Subject: BAR Actions - August 19, 2014 - 617 Park Street

BAR 14-06-02 617 Park Street Tax parcel 520186000 Chris and Megan Long, Owners/ Russell Skinner, Applicant New rear addition and site changes

# CITY OF CHARLOTTESVILLE BOARD OF ARCHITECTURAL REVIEW STAFF REPORT August 19, 2014

Please refer to the Site Plan.

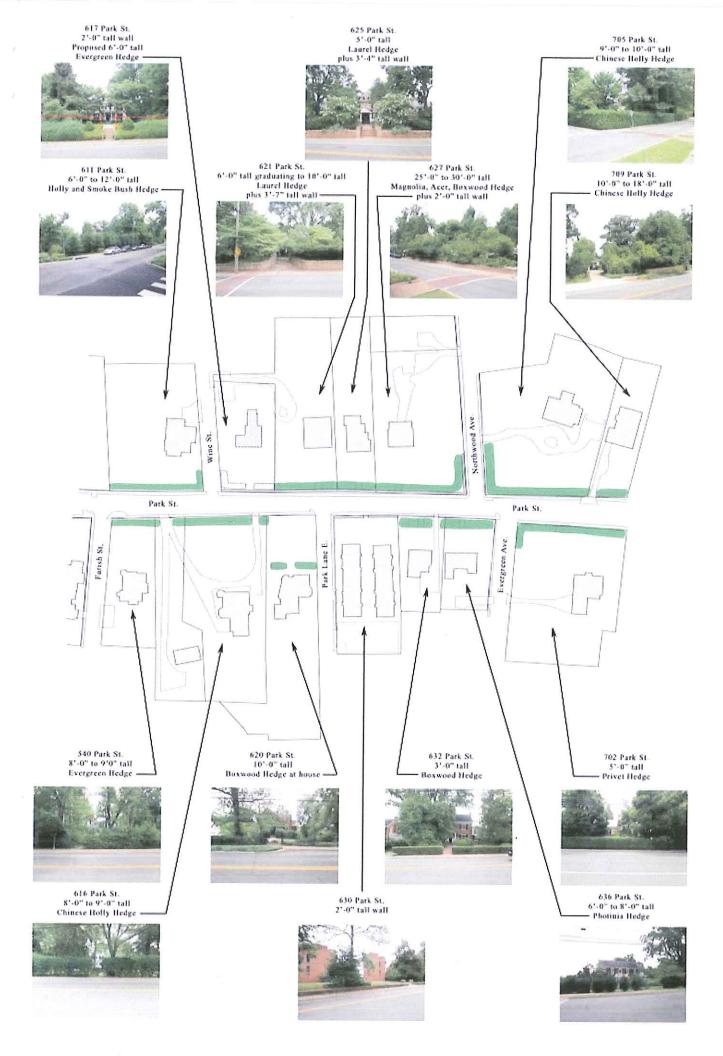
Regarding the proposed hedge along Park Street, our clients would like you to reconsider.

Our clients are a young couple enthusiastically looking forward to living in downtown Charlottesville. When they purchased their new property on Park Street, they maintained a reasonable assumption that they could treat the landscape in their front yard as so many of their neighbors have, that is, with an evergreen hedge. They would very much like to plant a 6 ft. high evergreen hedge in the front of their property facing Park Street.

Under the BAR's Section on Site Design Plantings, their wishes seem perfectly consistent not only with these guidelines, but with the existing adjacent landscapes. Please see the included sheet that indicates specific landscape treatments along Park Street adjacent to, or in close proximity, to 617 Park Street.

Our clients wish to use either Boxwood or Holly as hedge materials, both of which are clearly consistent with the existing nearby landscape. Nowhere in the guidelines does it suggest a limit on the height of the hedge.

The BAR approved (7-0) a Boxwood hedge along Park Street with a mature height of not over 4 feet, after a motion to allow a 6 foot high English Boxwood hedge failed (3-4), and a motion to deny the application for a 6 foot high American Boxwood was withdrawn.
